PUBLIC UTILITY COMMISSION OF OREGON  
STAFF REPORT  
PUBLIC MEETING DATE: July 17, 2018

SUBJECT: PACIFIC POWER: (Docket No. UM 1729) Annual and Post-IRP qualifying facility avoided cost update.

Figure 1. Standard renewable avoided costs

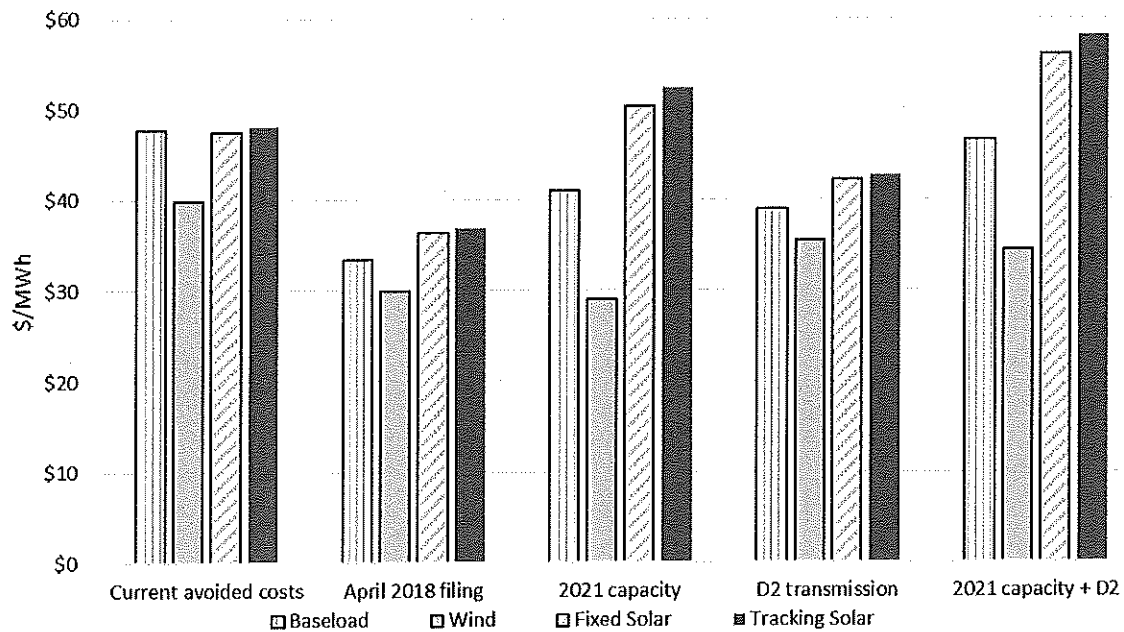
Table 2 below shows a summary of the various adjustments to standard renewable avoided costs as discussed in this report, and Figure 1 below is a graphical representation of the same.

However, when the capacity value is appropriately included during the entire renewable resource deficiency period, standard renewable avoided costs exceed standard nonrenewable avoided costs for three of the four QF types: Baseload, Fixed Solar and Tracking Solar.

However, wind renewable avoided costs do not revert to a higher avoided cost than nonrenewable when the capacity adder is included through the renewable deficiency period. This is partially a function of the changes in contributions to peak (CTP) from the 2015 IRP to the 2017 IRP, and the different methodologies for calculating capacity for the renewable proxy vs. the nonrenewable proxy.<sup>25</sup> As shown in Table 3 below, the wind CTP is reduced in the most recent IRP, while the two solar CTPs increase significantly. In addition, any capacity adder impacts effect wind from Oregon (west) differently than solar because of wind's lower capacity contribution than wind resources found in Wyoming (east).

First, Staff concludes that there is no basis for PacifiCorp's unilateral change to the renewable avoided cost methodology for calculating capacity payments to QFs. In order to conform to the methodology, PacifiCorp should refile its standard renewable avoided costs to include capacity payments during the entire renewable deficiency period, beginning in 2021. This would raise the renewable avoided costs of three of the four categories of generation above their nonrenewable avoided costs. However, wind's renewable avoided cost would remain lower than its nonrenewable avoided cost.

Second, Staff believes that the portion of transmission costs incurred by accelerating the construction of Segment D2 of Gateway West should be included as a component of the avoided renewable resource calculation and that PacifiCorp should work with Staff and stakeholders to develop this calculation.
